Enclosed please find a copy of the Environmental Evaluation Group's latest report, Review of the WIPP Draft Application to Show Compliance with EPA Transuranic Waste Disposal Standards, March 1996 (EEG-61).

REVIEW OF THE WIPP DRAFT APPLICATION TO SHOW COMPLIANCE WITH EPA TRANSURANIC WASTE DISPOSAL STANDARDS

March 1996

EEG-61
DOE/AL/58309-61

∞ x ∞ x ∞ ARRAY, 200 g Pu/DRUM
EFFECT OF H/Pu ON k-EFFECTIVE
239Pu-H2O, Full Volume
239Pu-H2O, Full Density, Flattened
239Pu-H2O, Full Density, H/D = 1.5
Infinite Multiplication Factor
1.5
1.4
1.3
1.2
1.1
1.0
0.9
0.8
0.7
0.6
500
1000
1500
NRC 10
NRC 5
NRC 11
NRC 6
NRC 2
NRC 3
NRC 4
NRC 1
SAR

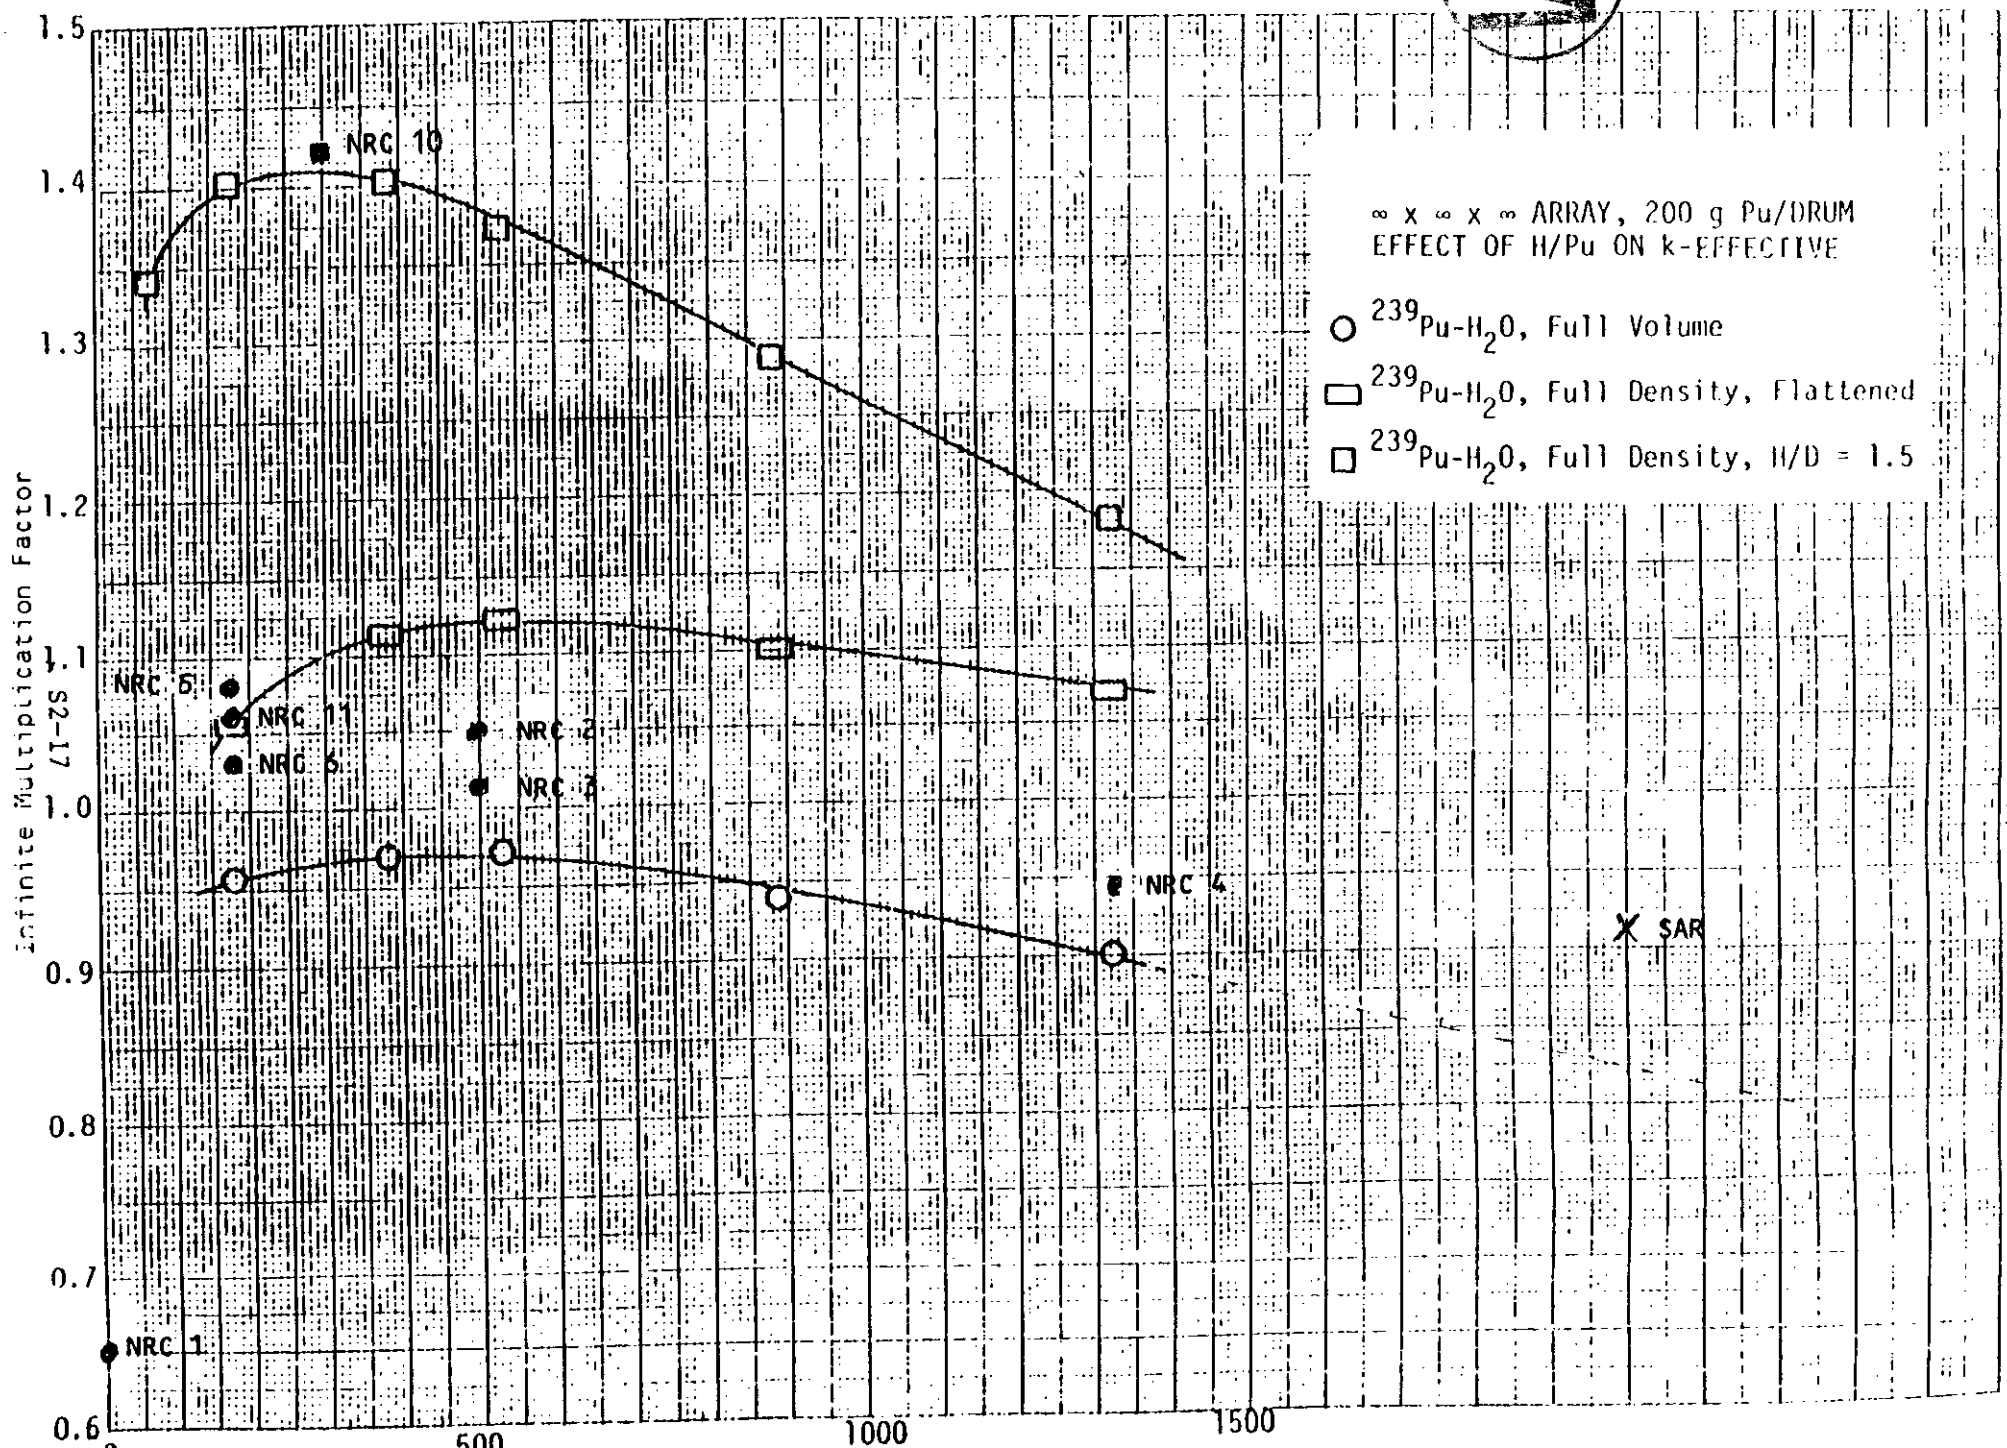
The calculations performed in Silver Spring, however, revealed some discrepancies which are not in the conservative direction (see Figure 3). Most of these calculations provided an independent check on the full volume infinite array analysis of Rockwell Hanford Operations. Eliminating the results which are not comparable on the basis of iron densities (Nos. 2 and 5 in Fig. 3) or cross section structure (No. 11 in Fig. 3), the multiplication factors calculated in Silver Spring are higher than those of Rockwell Hanford Operations by approximately +0.01 to +0.08. The single result for the full density array implies that the discrepancy is significant only for the full volume cases.
